Permit No: **941070**

RE: 1050 Westbrook ST.

Your application to construct enclosure for existing loading dock (walls & roof), has been reviewed and a permit is herewith issued subject to the following requirements: This permit does not preclude the applicant from meeting applicable State and Federal laws.

# Canopy at Loading Dock

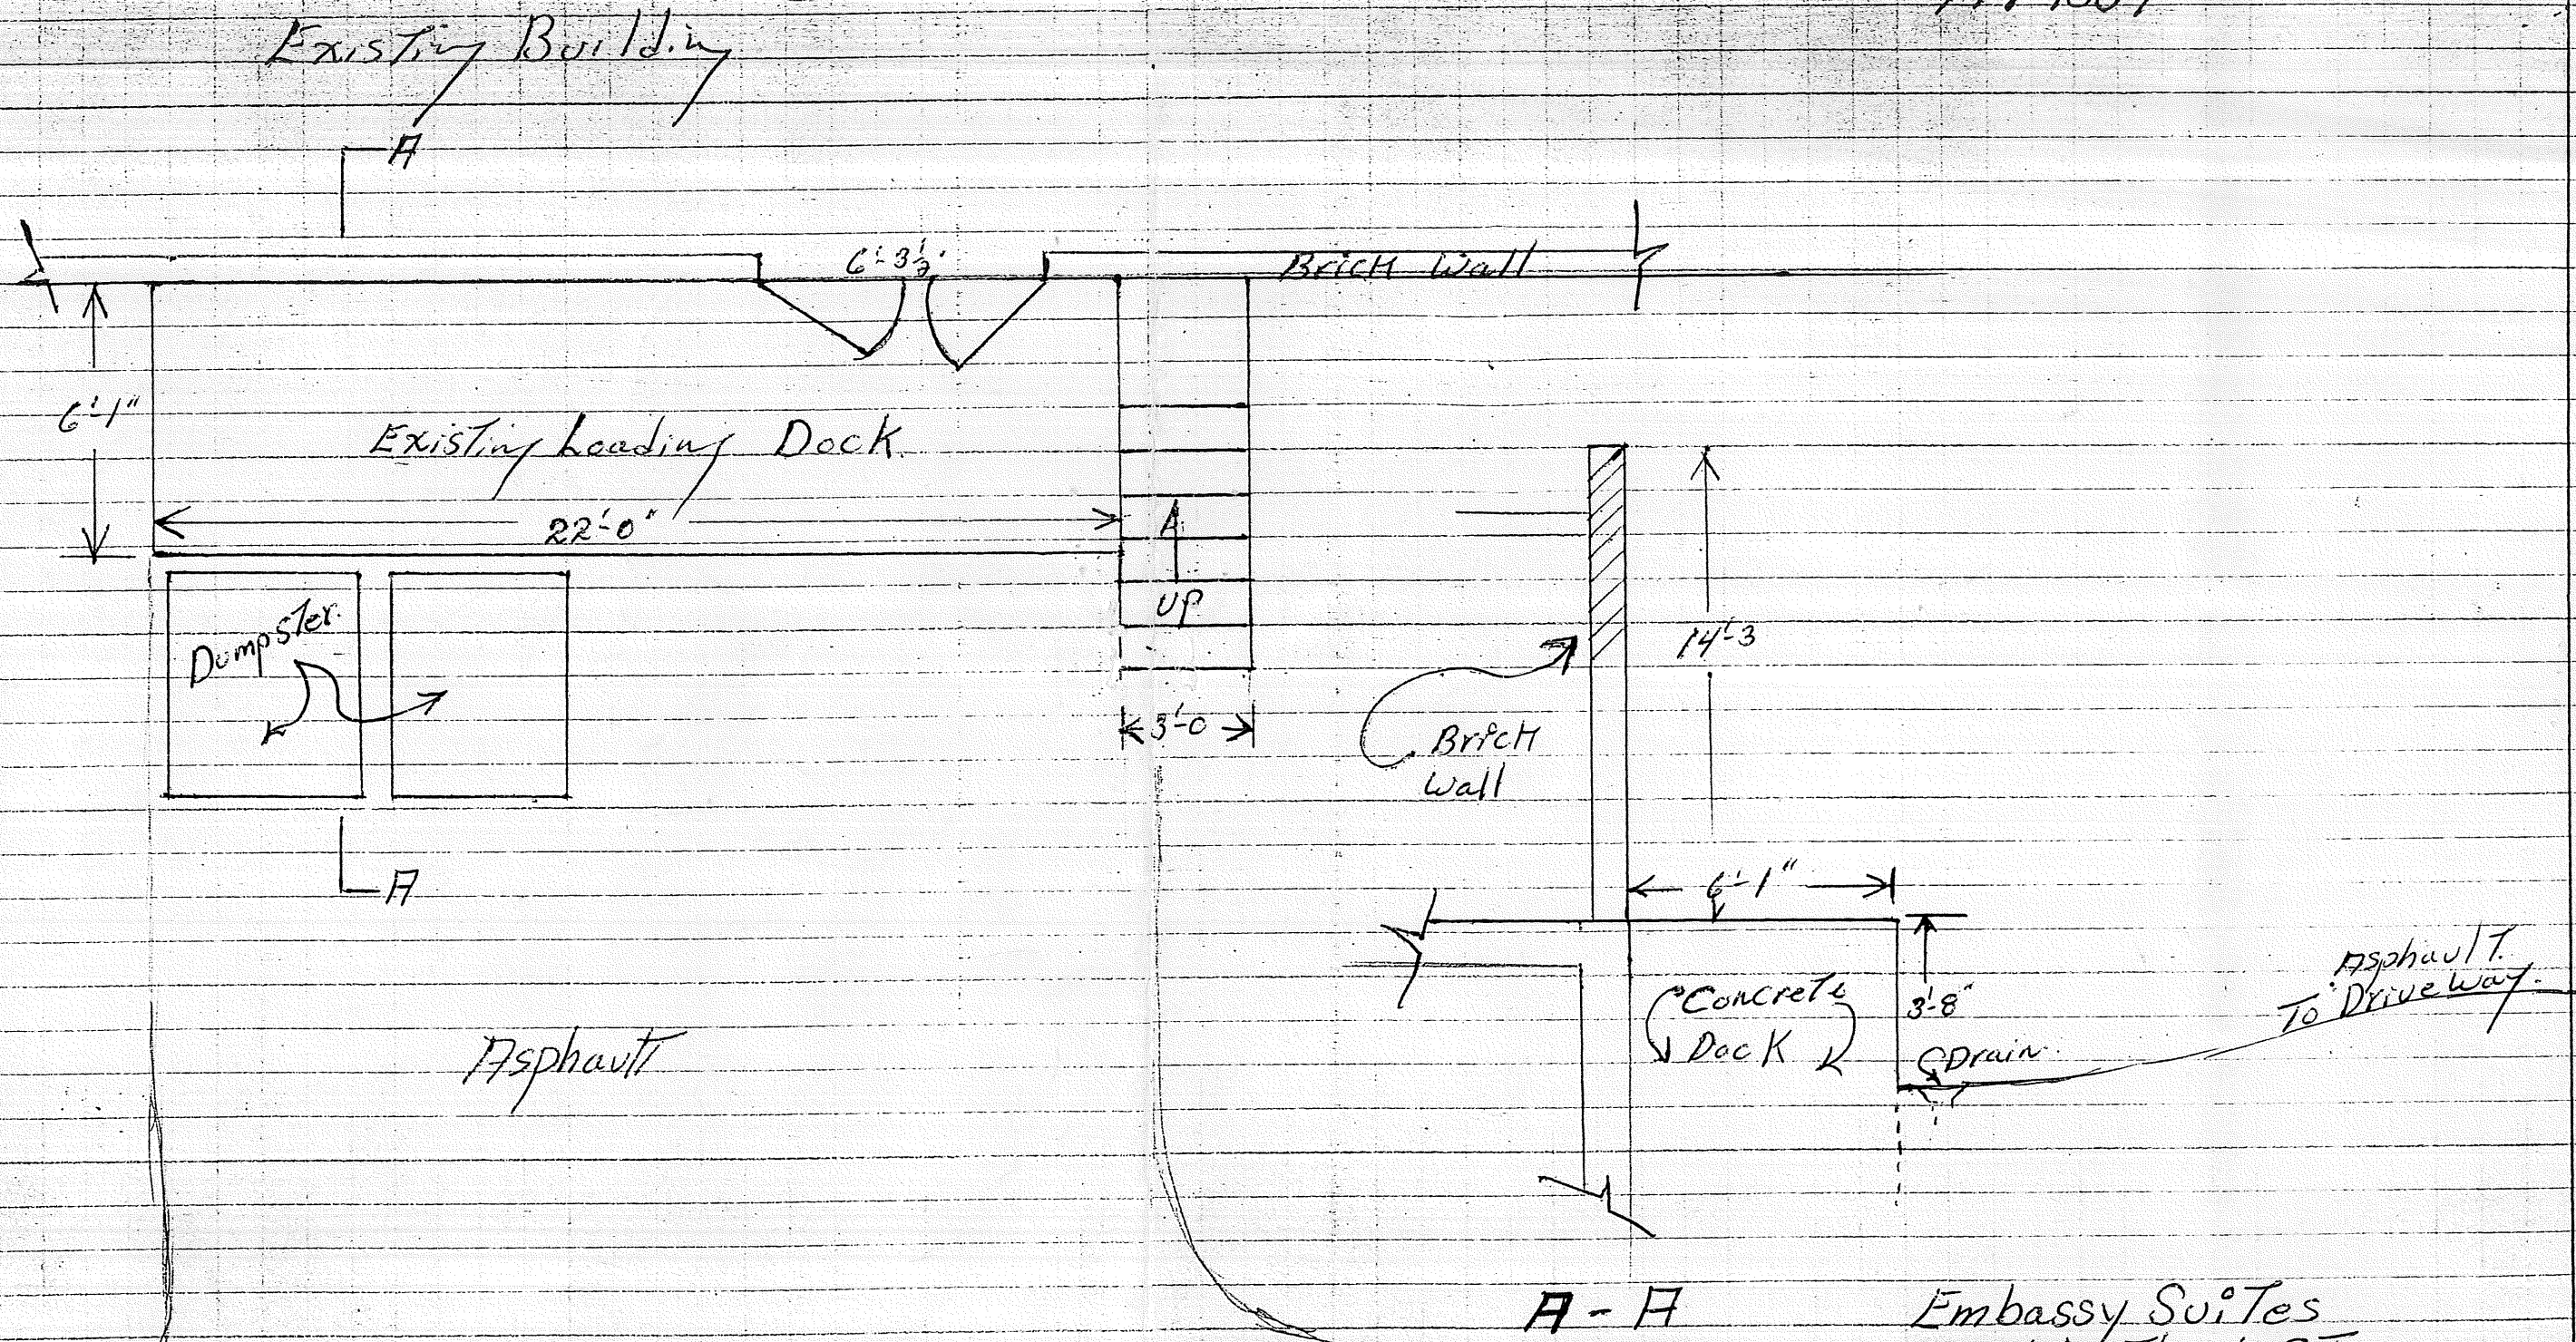
1. The automatic fire suppression system shall be provided throughout this proposed addition.
2. The doors leading from the loading dock to the hotel must have a fire rating of a one hour minimum.
3. The fire protective signaling system shall be extended into this new proposed area.
